IOWA STATE UNIVERSITY
OF SCIENCE AND TECHNOLOGY

Subject: Technical Specifications for the Iowa State University Reactor Facility
Update of Technical Specification Definitions

The addition of a definition for Confinement Secured to the Technical Specifications for the UTR-10 Reactor has been developed and is submitted for approval. The need for this addition is to provide clarity to Technical Specification 3.4.3.B. Also enclosed is the complete text of the Definitions section in which the material added has been underlined, building drawings, Technical Specification 3.4, and an explanation for the addition.

FIRST FLOOR PLAN

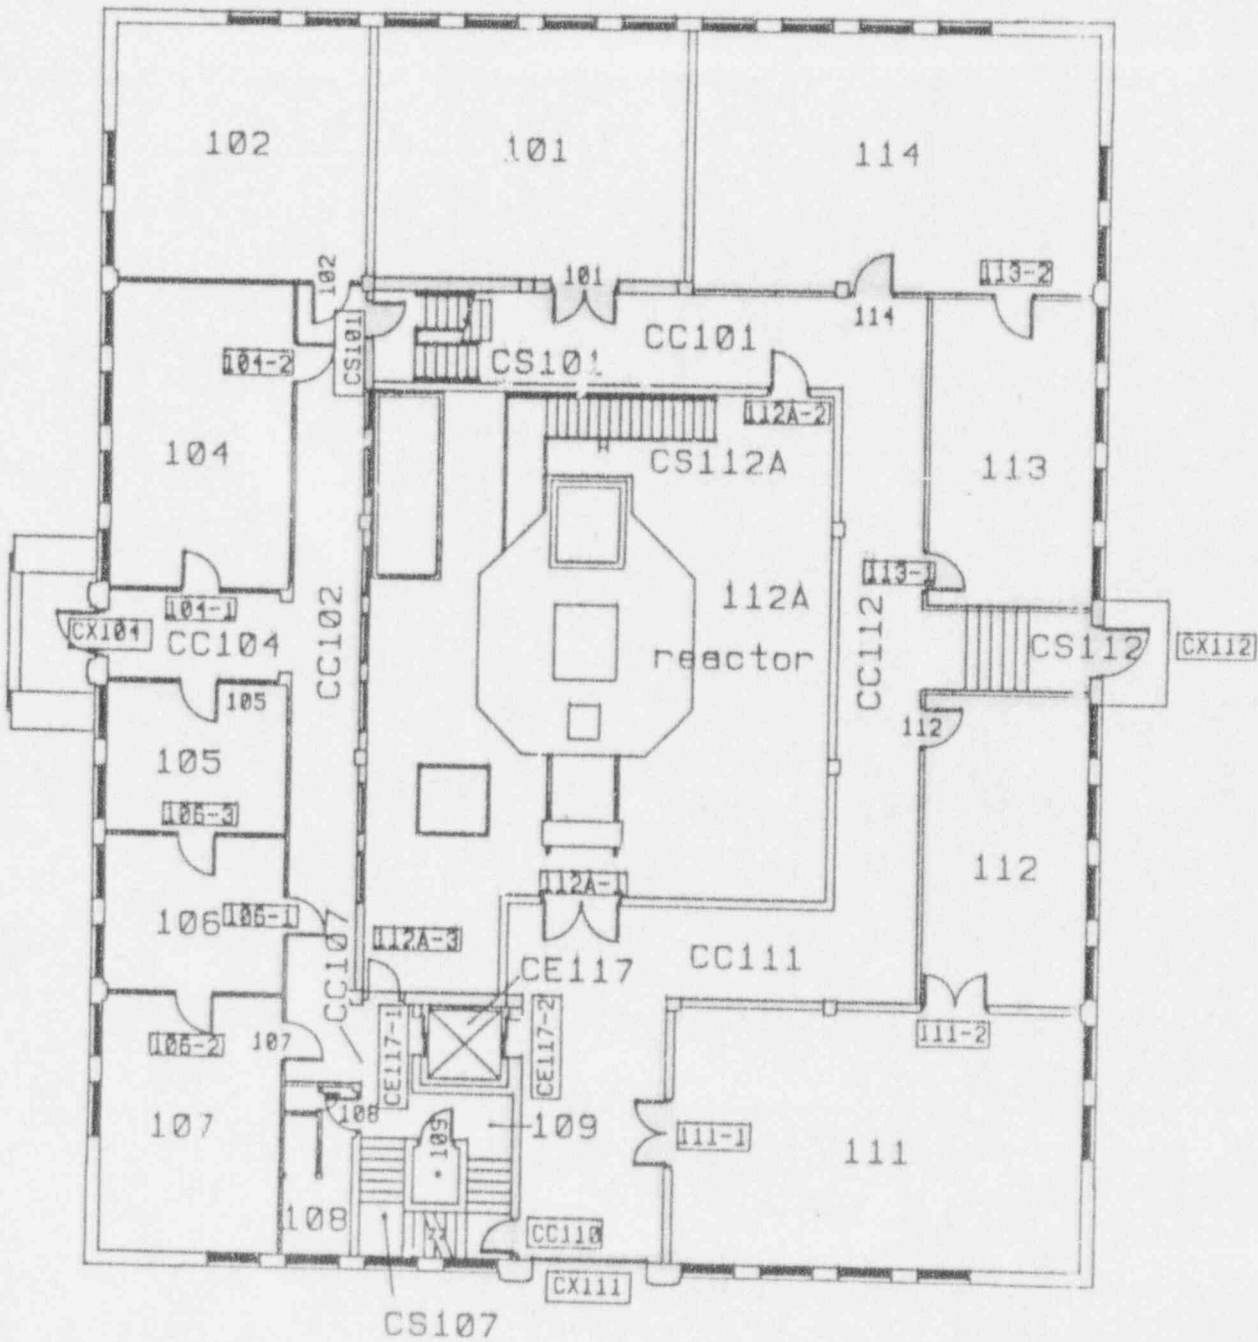
a. Doors 1-2, CS 101, 101, 114, 113-1, CX112, 112, 111-1, CX111, CC110, CE117-2, 112A-3, CE217-2, CC211, 209E, 210, 211, 213-1, 213-2, 214, 215 and CC201 are closed or are attended by a person with the ability to close the door in the event of an emergency, and

b. Windows on the north, south, east and west sides of the penthouse, on the west wall of room 112A, on the south wall of room 101, on the east wall above door CX112, on the north wall of room 111, and on the south wall of corridor CC201A, on the north wall of 209W and 209E are unbroken and closed or are attended by a person with the ability to close the window in the event of an emergency, and

SECOND FLOOR PLAN

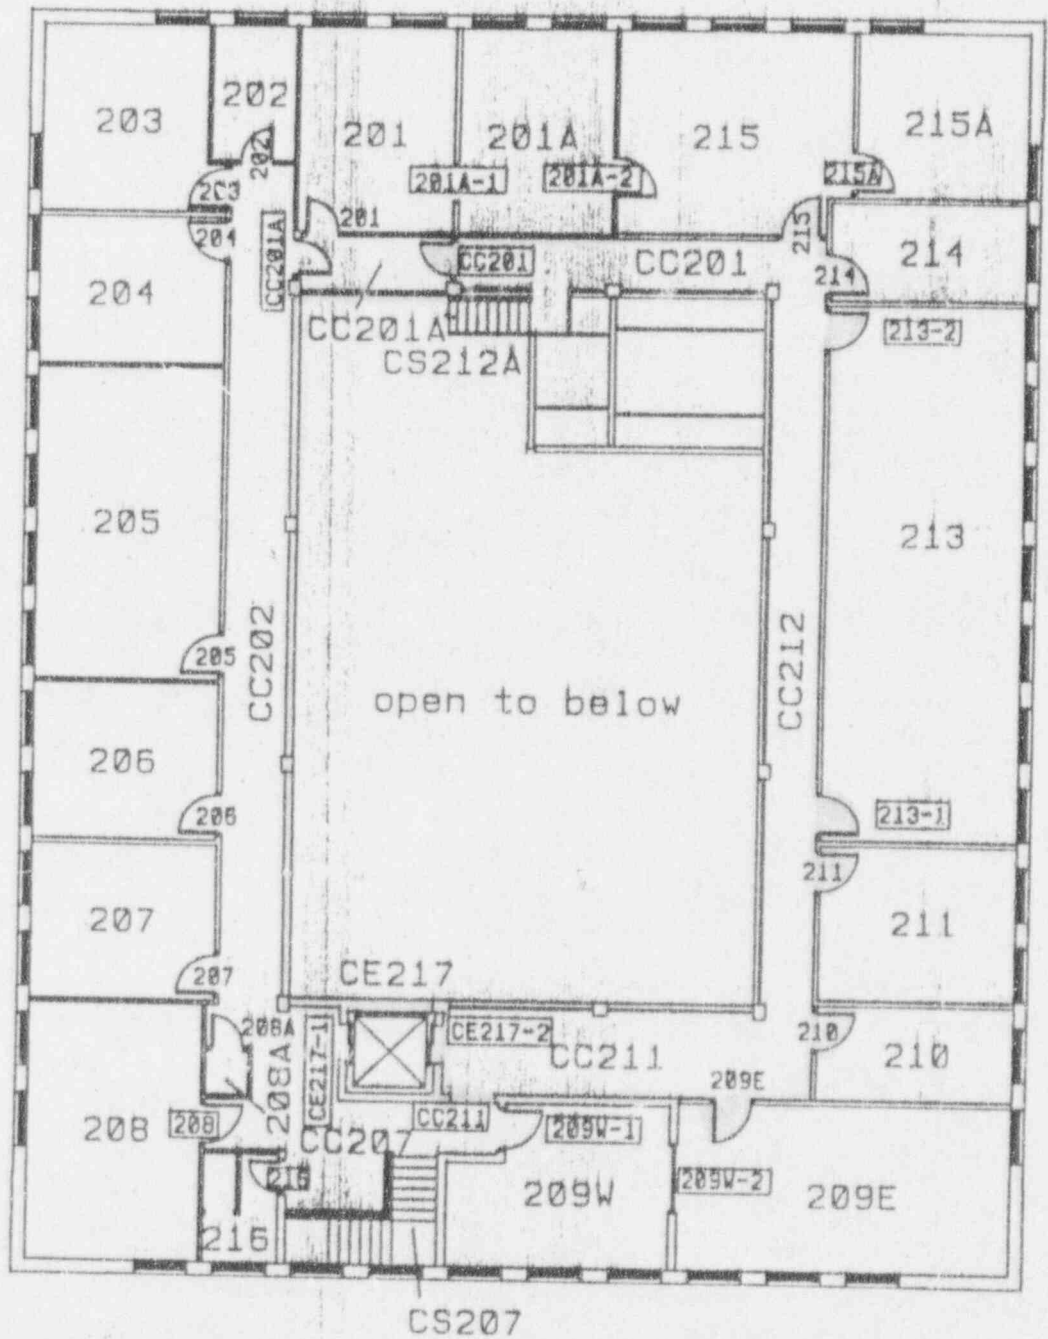
d. The roof covering the central bay area and second floor corridors CC201, CC212, and CC211 are intact and capable of performing as a non-pressure tight boundary.
